Well Name: POKER LAKE UNIT 13 DTD

Well Number: 217H

Notice of Intent

Type of Action: APD Change

WELL LOCATION AND ACREAGE DEDICATION PLAT

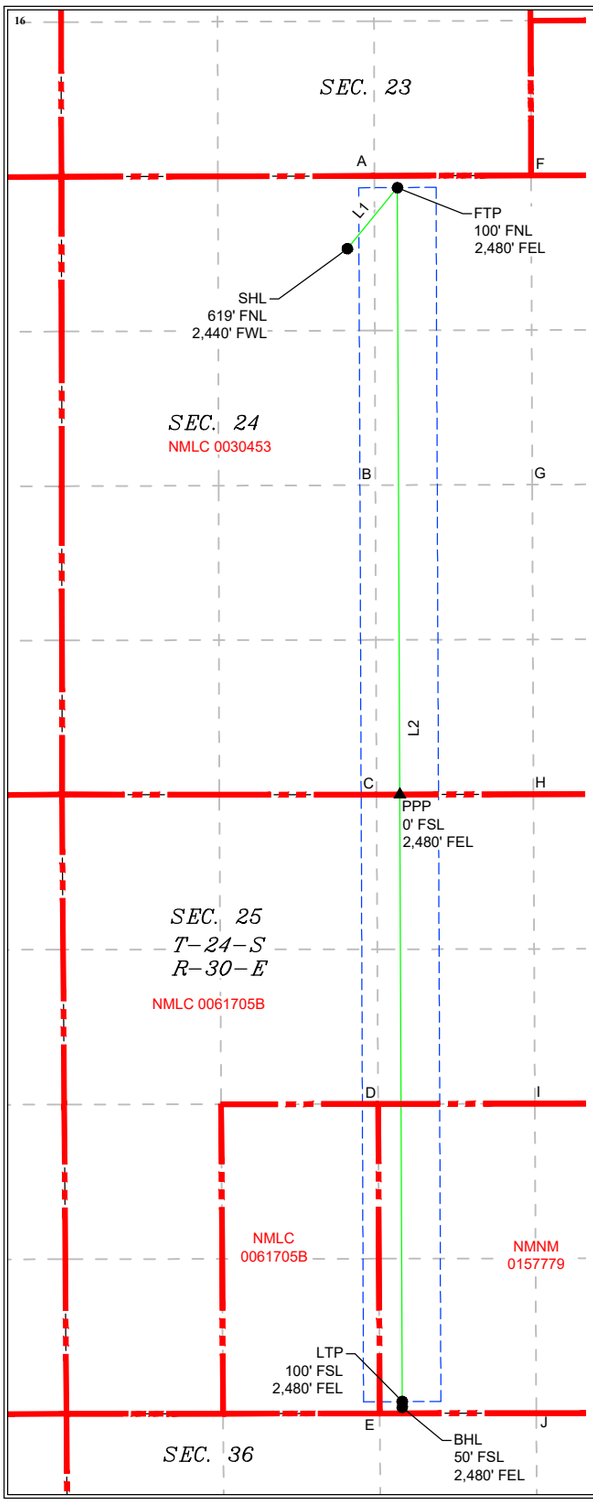
SHL: fr/619FNL & 2495FWL to 619FNL & 2440FWL, Section 24-T24S-R30E

FTP: fr/100FNL & 2090FWL to 100FNL & 2480FEL

LTP: fr/100FSL & 2090FWL to 100FSL & 2480FEL

BHL: fr/50FSL & 2090FWL to 50FSL & 2480FEL, Section 25-T24S-R30E

UL or lot no.	Section	Township	Range	Lot Idn	Feet from the	North/South line	Feet from the	East/West line	County
C	24	24S	30E		619	NORTH	2,440	WEST	EDDY

UL or lot no.	Section	Township	Range	Lot Idn	Feet from the	North/South line	Feet from the	East/West line	County
O	25	24S	30E		50	SOUTH	2,480	EAST	EDDY
